STAFF'S
REQUEST ANALYSIS
AND
RECOMMENDATION

05PS0119

JMS Investments LLC
(Harpers Mill)

REQUEST: Approval of the schematic plan for a proposed mixed use development.

05PS0119
HARPERS MILL

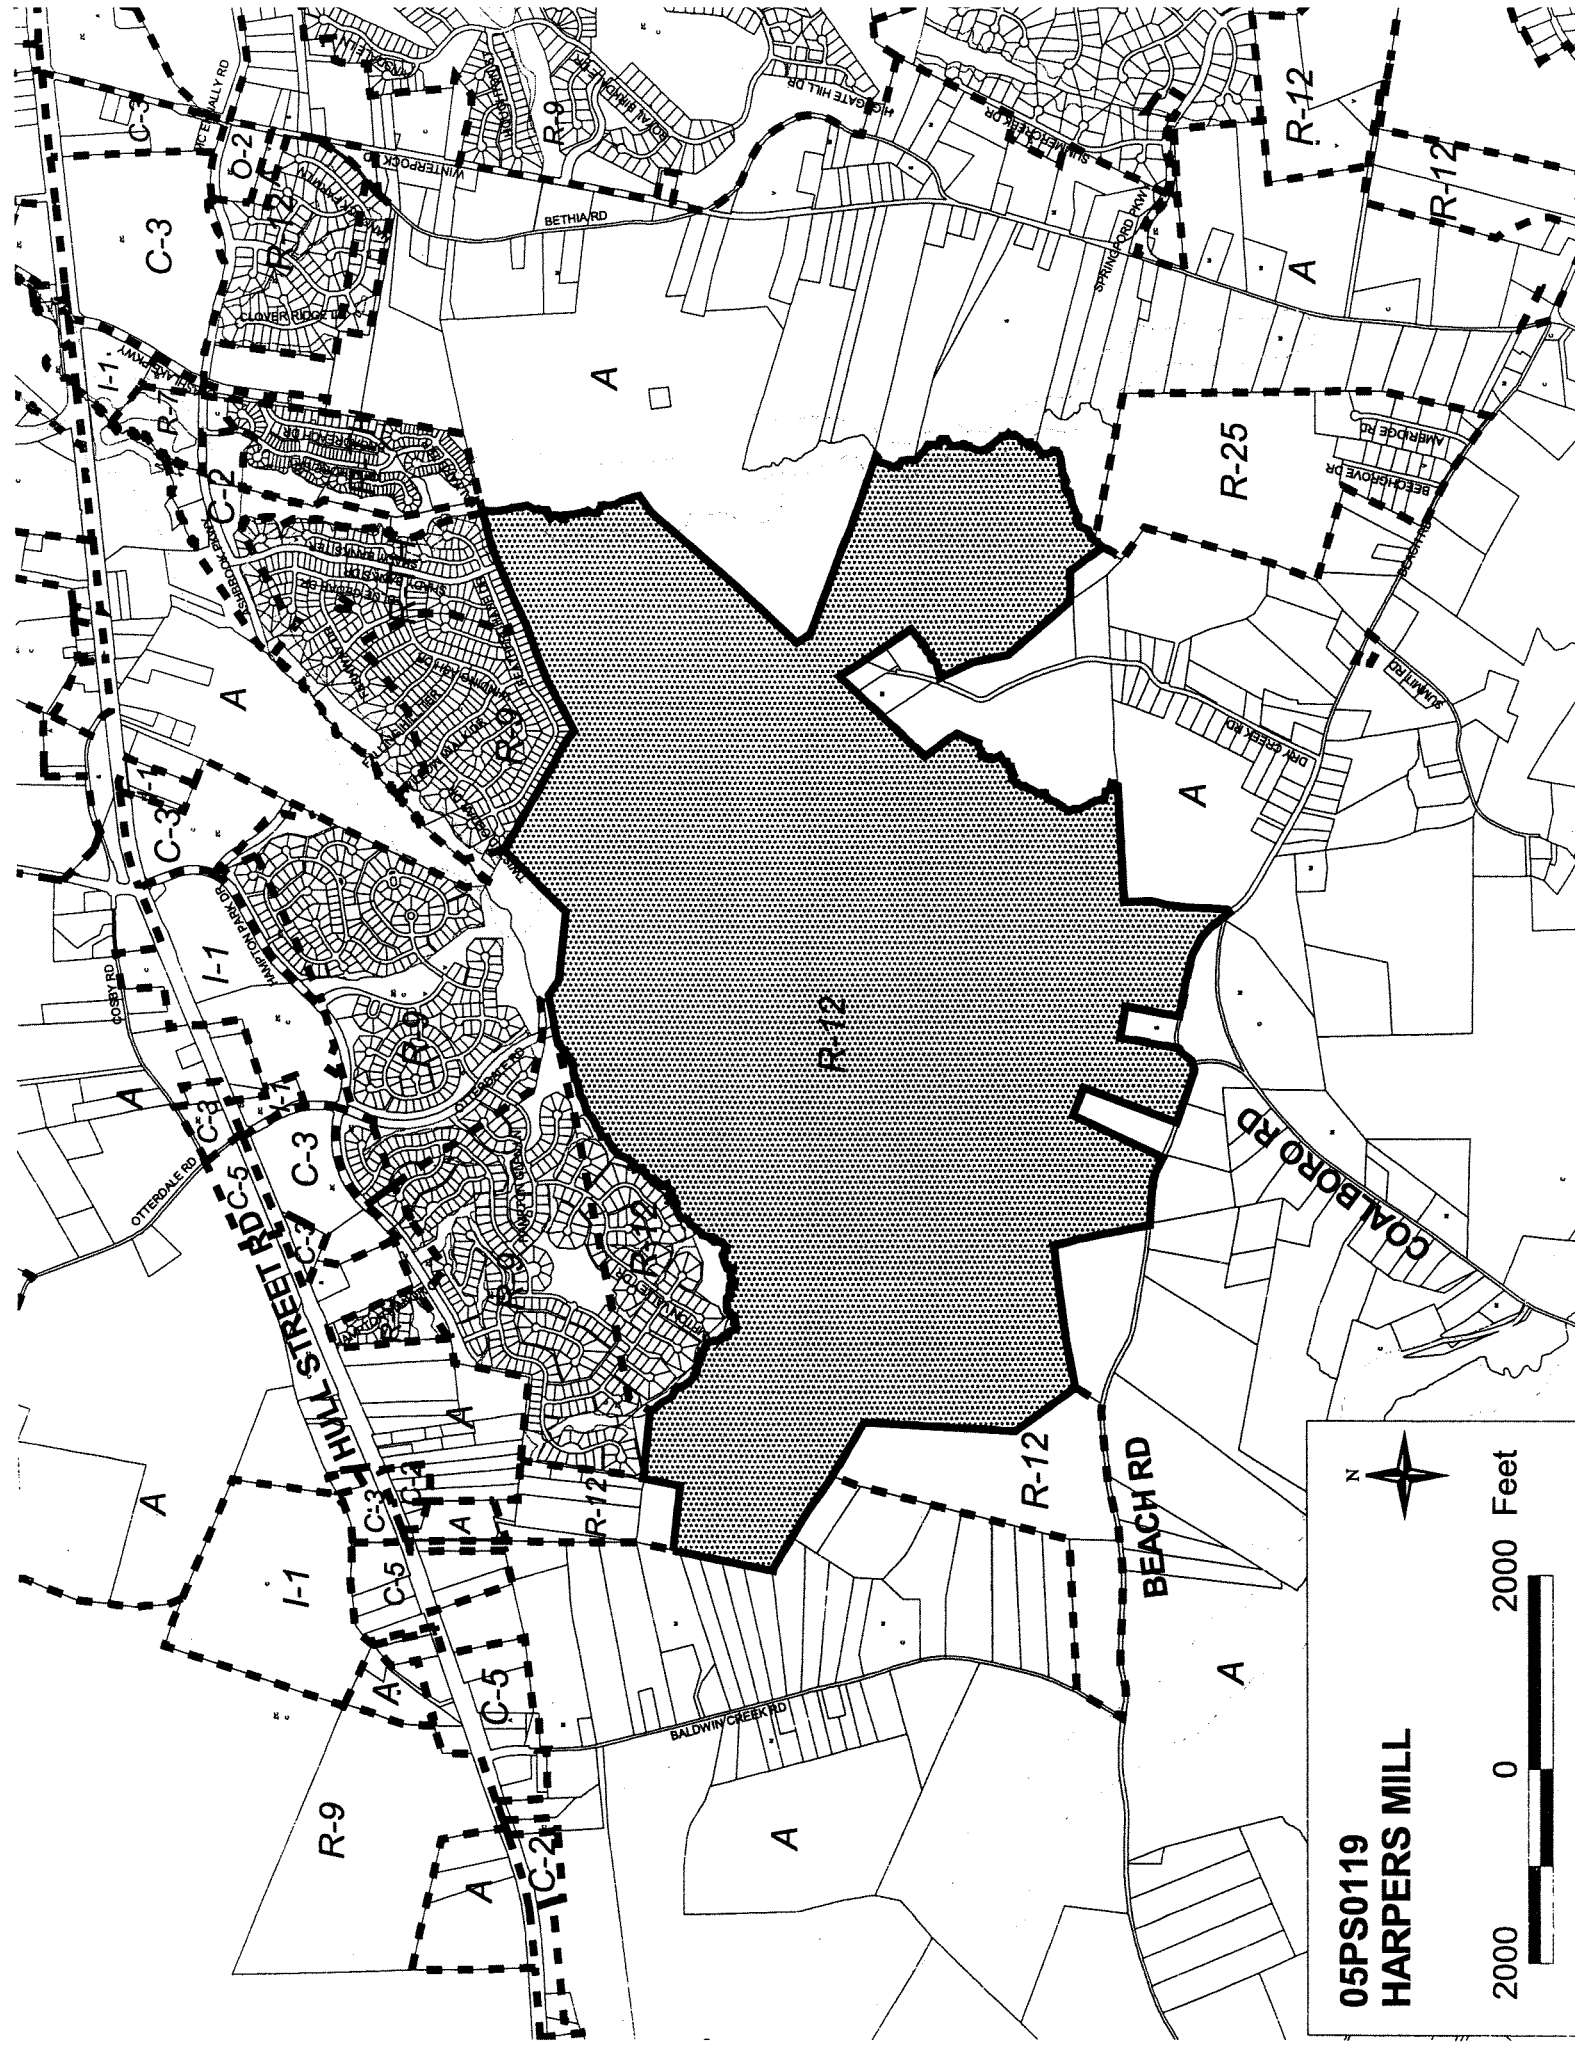
1. A fifty (50) foot undisturbed buffer shall be provided on the L-2 commercial tract excluding any public streets to the adjacent residential tract as approved through the conceptual plan or tentative subdivision plat approval. Any additional buffers required to provide transitions between other uses and or streets shall comply with the depth of the buffer required through the conceptual plan, site plan or tentative subdivision plat approval. All buffers shall comply with the standards established in Section 17-70 of the Subdivision Ordinance. (P)

2. If the applicant chooses to develop anything other than residential uses excluding single family (R-12) in tracts H, I and L-1 a conceptual plan depicting the locations of and transitions between uses shall be submitted for approval. Uses permitted to occur in these tracts subject to this approval process are cluster residential, townhome, multifamily (age restricted) and cluster condominium. Any other use permitted in those tracts by zoning shall be approved through an amended schematic plan, ~~approval~~. (P)

3. The provision for adequate vehicular and pedestrian access from the residential tracts to the recreation areas shall be evaluated through the tentative plat review. Vehicular accesses shall not serve as cut throughs to access the adjacent residential tract from major streets. (P)

4. The location of Otterdale Road, a ninety (90) foot Urban Minor Arterial, running generally north to south through the center of the property and, a ninety (90) foot Urban Minor Arterial (Harpers Mill Parkway) generally east to west through the center of the property is acceptable but specific comments relative to horizontal and vertical curvature will be withheld until the time of tentative review. The access points on Harpers Mill Parkway and on Otterdale Road are generally acceptable. However, the exact location of these access points will be determined at the time of tentative or site plan review. (T)

5. The proposed internal subdivision road network shall be determined to comply with the Planning Commission's Sub Road Policy of not exceeding 1,500 vehicles per day on streets that have lot frontage at the time of tentative review. (T)

6. The developer shall submit a preliminary design for the connection of Harpers Mill Parkway extended to Winterpock Road and Baldwin Creek Road. The specific requirements for the design will be imposed at the time of tentative review. (T)

7. The developer shall comply with turn lane requirements for Otterdale Road and Harpers Mill Parkway as established at the time of tentative review. (T)
